4-1. Gaseous and Airborne Particulates (Section 4.1)

Energy Metals Corporation
Responses to NRC Request For Additional Information
Moore Ranch Uranium Project Source Material License Application

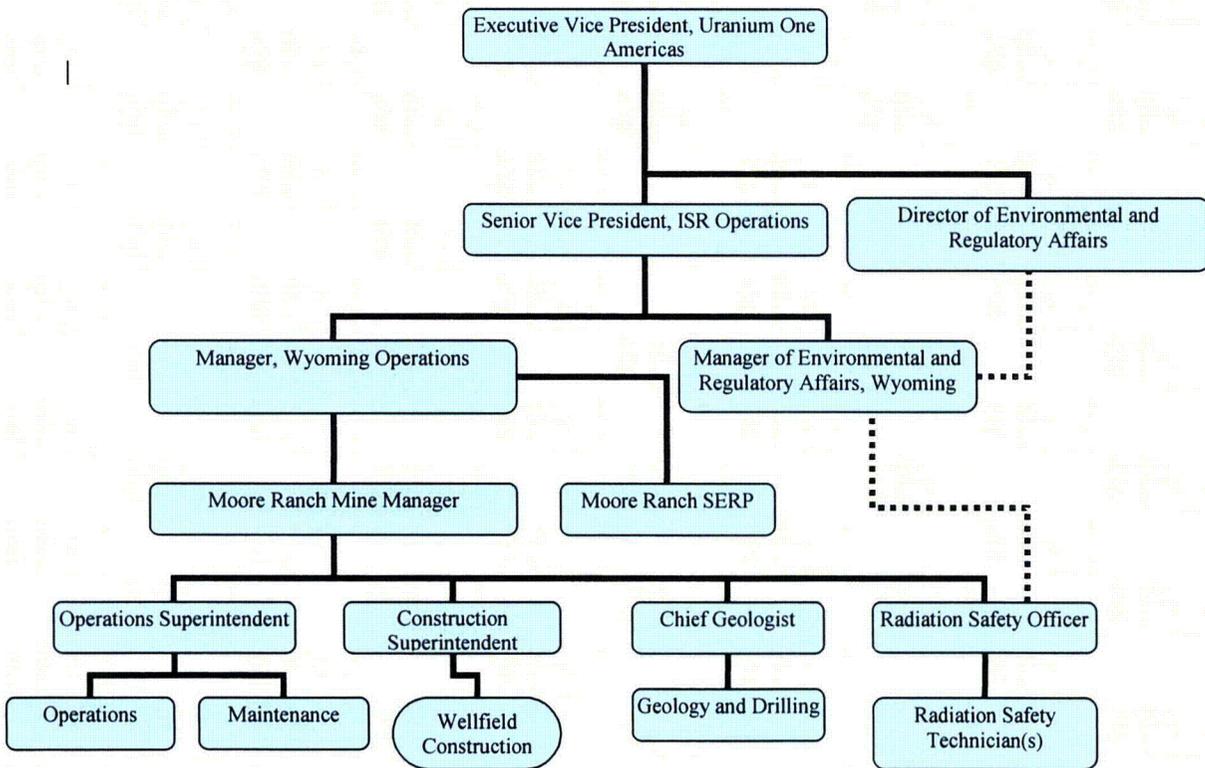
Other than the RSO and the Radiation Safety Technicians, the description of the Moore Ranch organization provides no information regarding site management, i.e., the plant supervisor and those that report to that position. Please discuss the corporate organization to the site level management positions. This should include the independence of the plant supervisor, RSO, and SERP for raising significant safety issues to senior management, and show the integration among groups that support construction, operation, and maintenance of the facility.

The organizational chart in Section 5.1 was revised to reflect site level management positions as shown below. Position descriptions for the site level management were also provided in Section 5.1

Figure E-1.f(1) Production and Restoration Sequence, Ingaray Mine Units 1 through 9

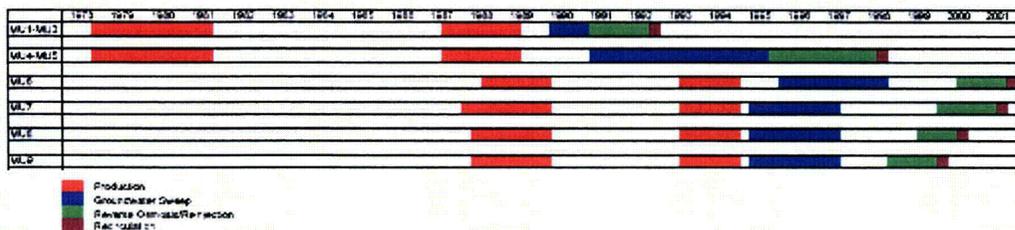
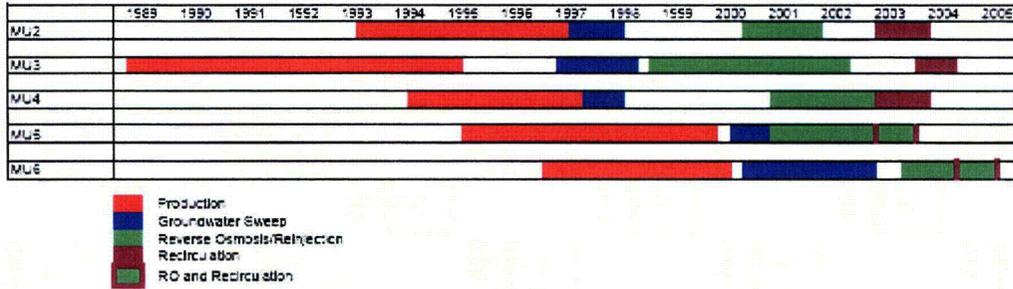
- f. Justify in detail the six pore volumes estimate for each of the wellfields, which appears very low, using a basis of comparable field experience or revise the estimate. Reported field case pore volumes from the similarly situated COGEMA Irigaray ISL Units 1-9 ranged from 9.5 to 18.4 with an average of 14.6 to achieve restoration. If the applicant retains the estimate of six pore volumes, it should provide a substantial justification using analytical methods or numerical modeling. These estimates should also take into account unique issues presented by the

unconfined aquifer setting at Moore Ranch and address any difference in pore volumes needed if biological reductants are used. Provide a new schedule for restoration if the estimated number of pore volumes for restoration is revised. (See also RAI 6-6.)

Restoration was not performed immediately following the completion of production, and in some cases, there were long periods of inactivity during the production and restoration phases. At Irigaray, production was interrupted for a period of almost six years in MU1 through MU5 [Figure 6-1.f(1)]. Similarly, there was a three-year break in production in MU6 through MU9, when the operation was in standby status. Restoration did not commence at MU1 through MU3 until a year after production had ended. At MU4 and MU5, restoration operations did not begin until two years following production. Restoration commenced shortly after the end of production at MU6 through MU9. However the project was on standby status between the completion of groundwater sweep and the beginning of the RO phase of production, resulting in a break of one to two years, depending on the MU. Restoration was initiated sooner after the end of production at Christensen Ranch, with the exception of MU3 and MU4. However, there were periods of standby between groundwater sweep and RO treatment/injection of up to a year. These delays between and during production and restoration operations most likely increased the number of PVs required to complete aquifer restoration. Uranium One will commence restoration activities upon completion of production within a wellfield.
